CENTRAL WATER RECLAMATION FACILITY
 REGIONAL LIFT STATION "A"
 ESCAMBIA COUNTY, FLORIDA
 EMERALD COAST UTILITIES AUTHORITY
 E.C.U.A. PROJECT NO. CST41B

SHEET TITLE:
GRADING, DRAINAGE, AND LANDSCAPE PLAN
 SHEET NUMBER:
C1.4

DATE	DESIGNED BY	DRAWN BY	PROJECT	CIVIL ENGINEER	MANAGER	S.I.M.M. PROJECT NUMBER	DATE	REV.	REVISION DESCRIPTION
MARCH 2008	S. D. W.	J. E. A.	GENERATOR SLAB MODIFICATION	S. D. W.	D. KECK	227803DD04	03-24-08	0	ISSUED FOR BID
							04-09-08	1	ADDENDUM #1
							03-08-09	2	GENERATOR SLAB MODIFICATION
							03-25-09	3	DRAINAGE GRADING & STABILIZATION MOD.'S

SHEET TITLE:
GRADING, DRAINAGE, AND LANDSCAPE PLAN

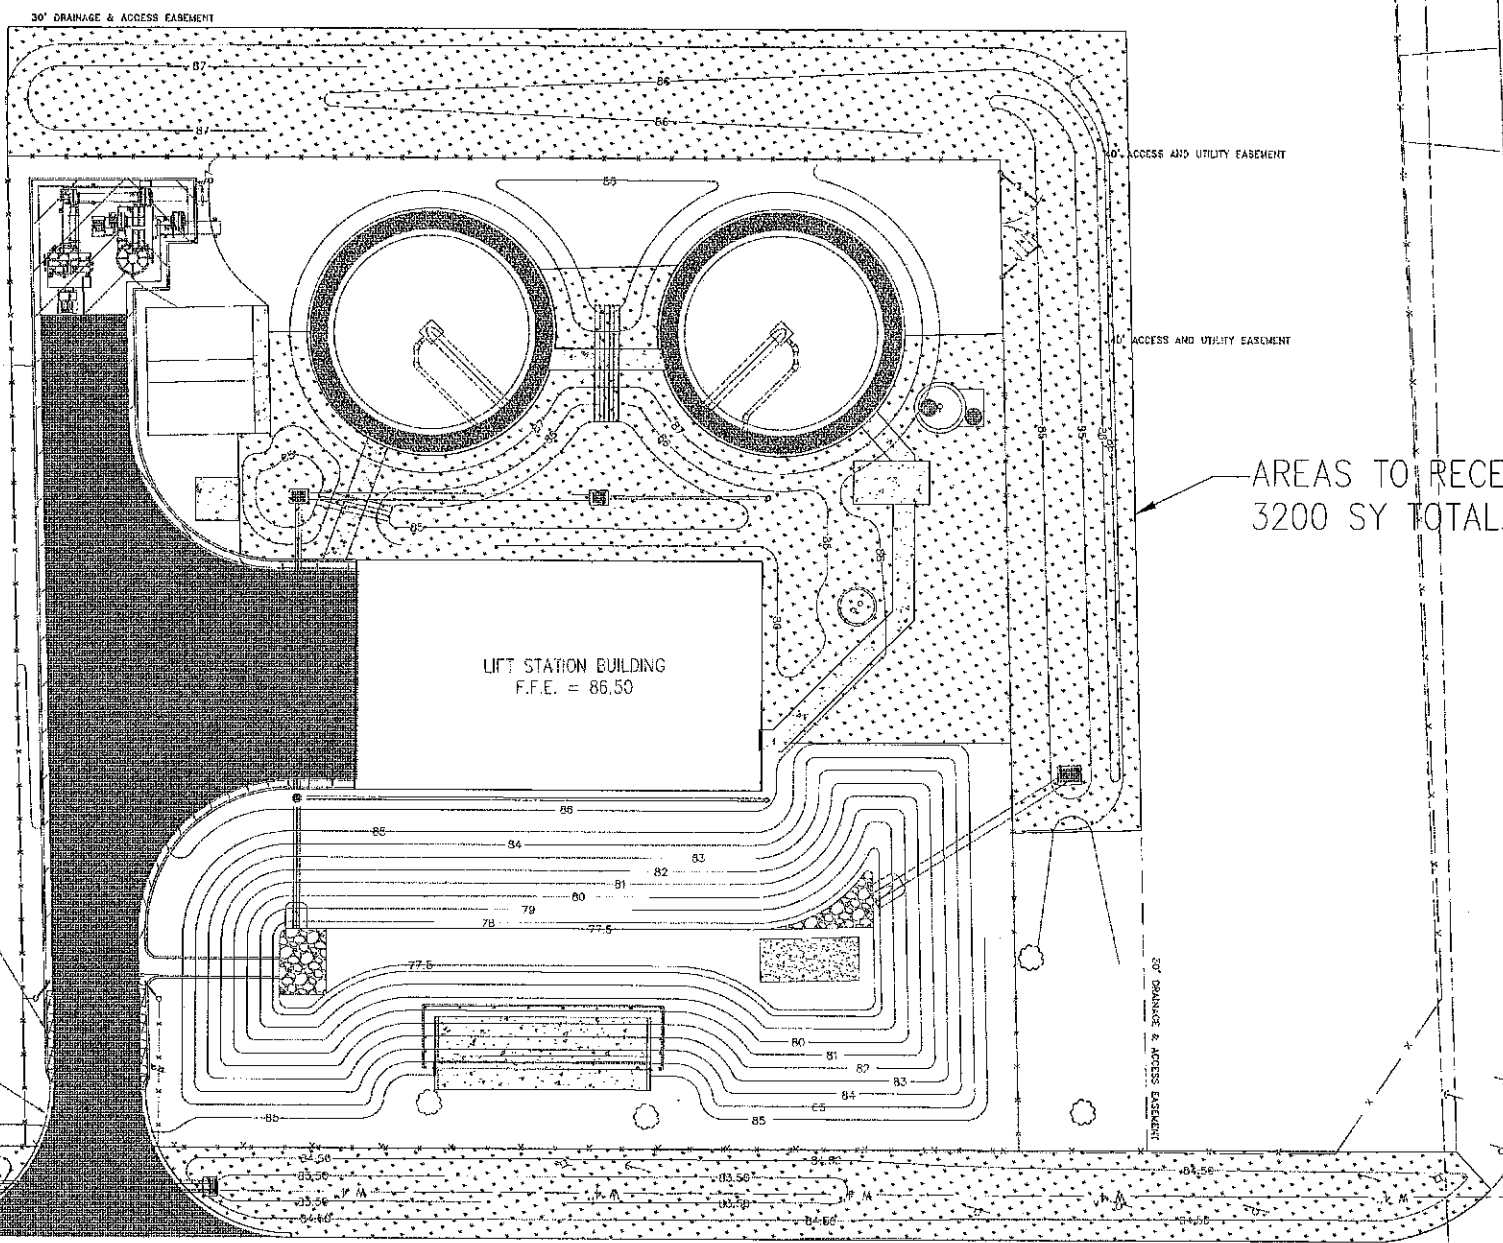
AREAS TO RECEIVE SOD
 3200 SY TOTAL.

PROVIDE:
 FDOT TYPE F CURB AND GUTTER (TYP)

PROVIDE:
 3' TRANSITION FROM TYPE F CURB AND GUTTER TO 12" RIBBON CURB
